TRAIL & SIDEWALK FEASIBILITY STUDY – PHASE 1

Madeline Avenue, From County Road 483 (Clyde
Morris Boulevard) to State Road 5A (Nova Road) &
Bruner Road, From Stillwood Court to Madeline
Avenue

City of Port Orange

FINAL Report, January 2019

Figure 1
Project Location Map

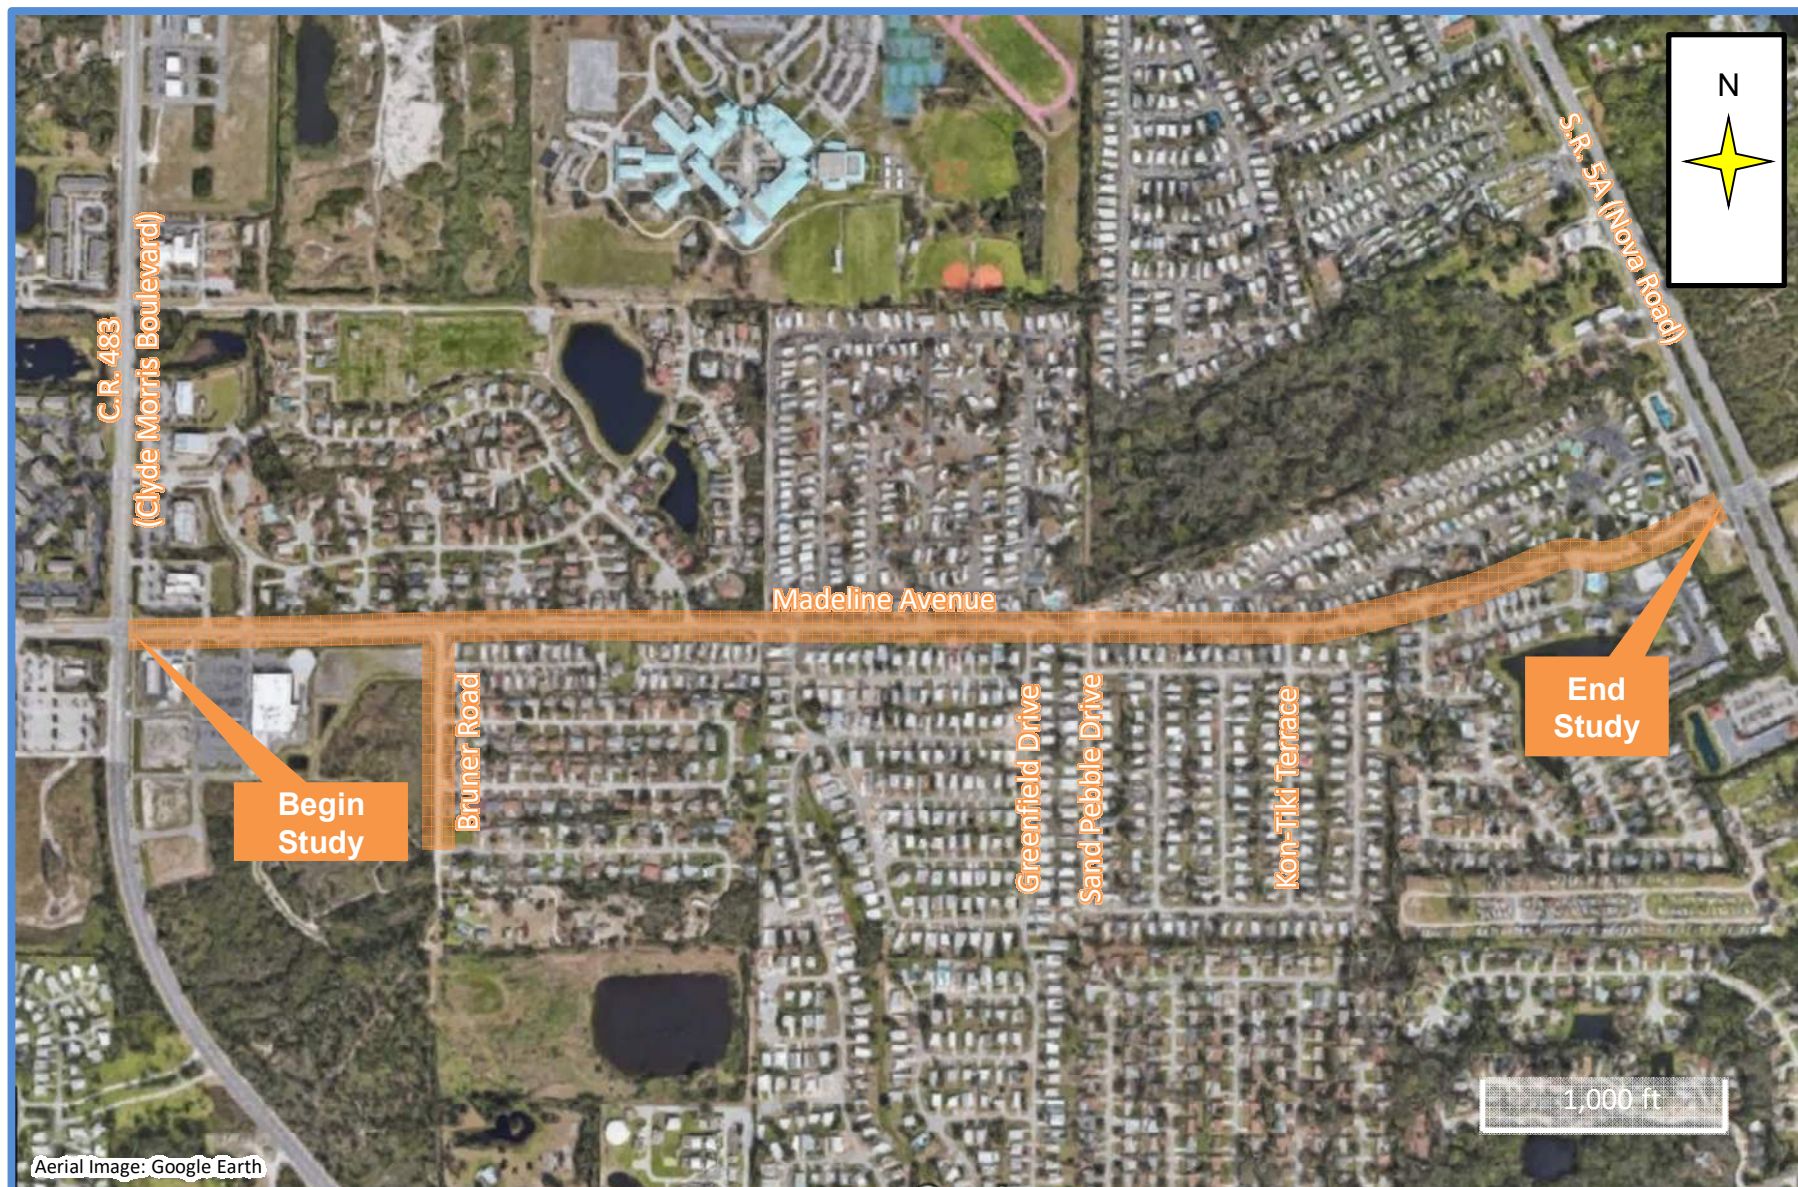
1. Include Bruner Road in the following:
 - a. Report title
 - b. Figure 1 Project Location Map

1. Page 2; Project Location Map – Include a scale on Figure 1.

TYPICAL SECTION 04
MADELINE AVENUE
STA 272+60 TO STA 290+30

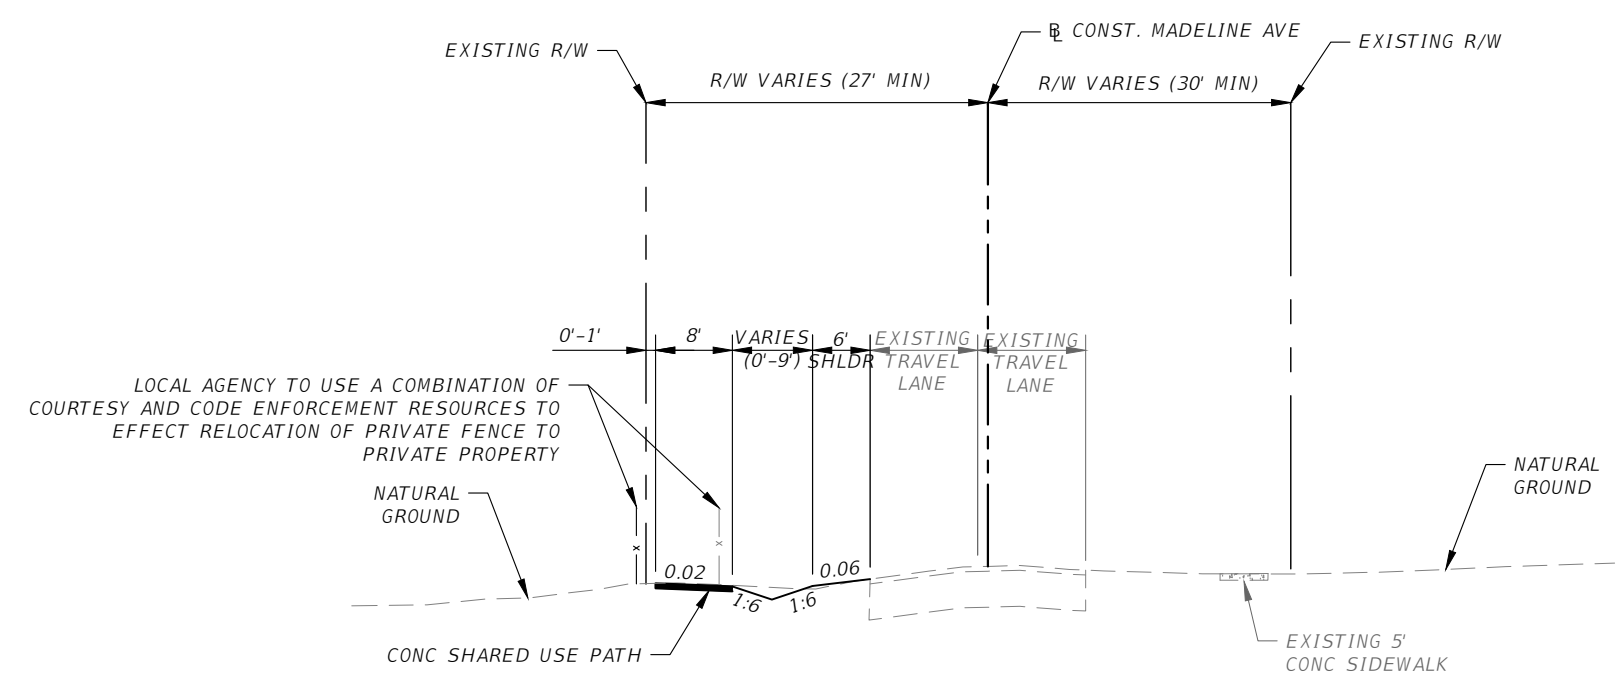
3. Sheet 11,12 Concepts – drainage Sta. 286+40 to 290+30 LT: This section does not appear to match the shoulder/drainage shown by the typical section. What is proposed along within this range?

Response: Right-of-way is constrained in this area (station 286+40 to 290+30). Please see revised Typical Section 4 has been revised to show a minimum dimension of 0' between the right-of-way and the shared use path, and revised Sheets 11 and 12 where the sidewalk has been placed out at the existing right of way such that a small swale can be achieved between the trail and the roadway.

TYPICAL SECTION 07
BRUNER ROAD
STA 500+50 TO STA 509+75

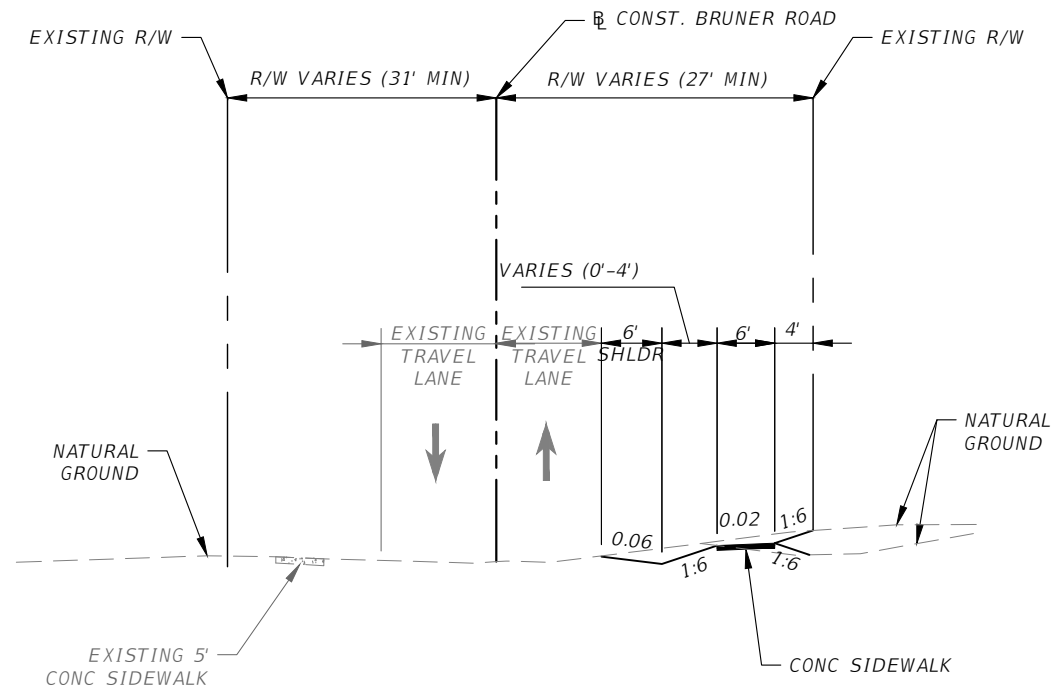
2. The original Feasibility Study application was for a minimum 5' sidewalk along the east side of Brunner Road and the draft Feasibility Study calls for a 6' sidewalk (Sheet 4, 7 and 16). City request it is indicated in the Feasibility Study that the sidewalk along the east side of Brunner Road be designed as 6' wide with alternate bid quantities for a 5-foot sidewalk with a one-foot wide earthen berm between top of swale and 5-foot sidewalk to accommodate a 6-foot sidewalk. City may opt to build a 5' wide sidewalk to reduce construction and future maintenance cost.

REVISIONS				MADELINE AVENUE TRAIL & SIDEWALK PHASE 1			CONCEPT PLANS PHASE 1	SHEET NO. 5
DATE	DESCRIPTION			ROAD NO.	COUNTY	FINANCIAL PROJECT ID		
1/22/2019	REVISED PER CITY, FDOT, AND R2CTPO COMMENTS			..	VOLUSIA	----

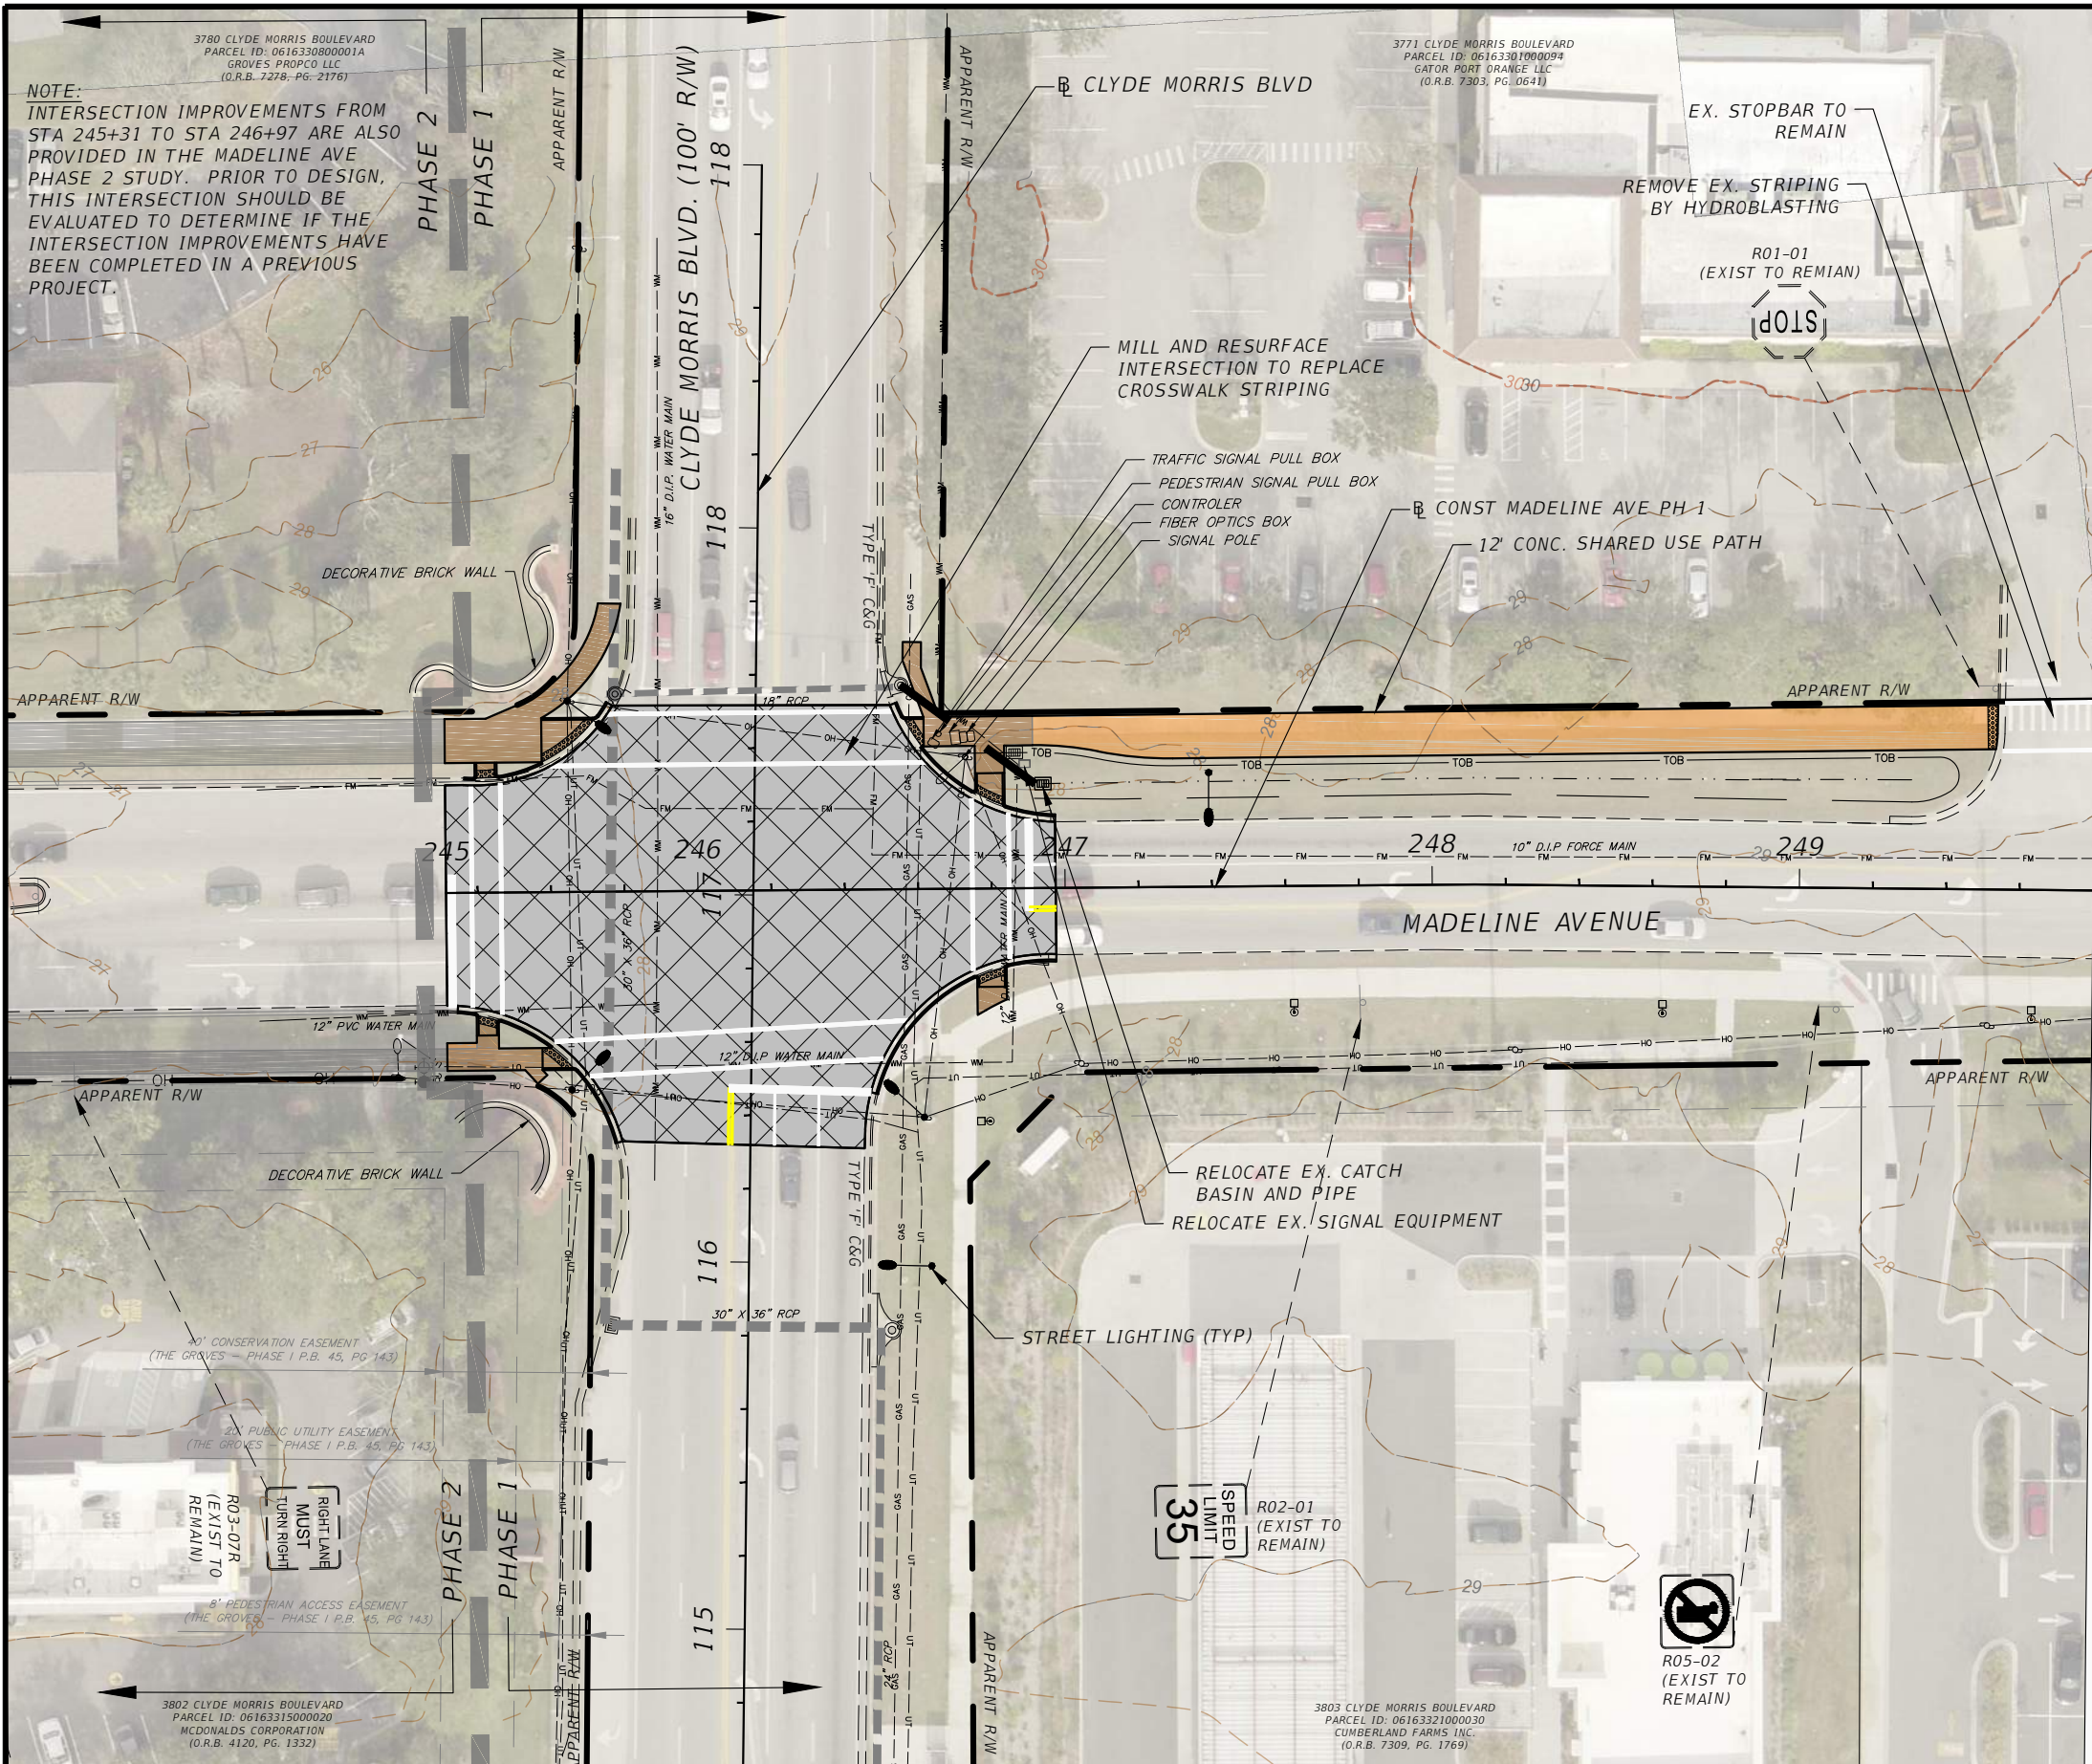
4. The Feasibility Study application was for a minimum 8' sidewalk/multi-purpose trail along the north side of Madeline Avenue and the draft Feasibility Study calls for sidewalk/multi-purpose trail width between 8' to 12' (Sheet 5, 6, and 7). City request it is indicated in the Feasibility Study that the sidewalk/multi-purpose trail along the north side of Madeline Avenue be a minimum of 8' wide to give flexibility on the width during design. City may opt to build an 8' wide sidewalk/multi-purpose trail to reduce construction and future maintenance cost.

1. Sheet 5 Concepts – relocate existing cabinet: does this work belong with Ph.II caused by the sidewalk/ramp work?
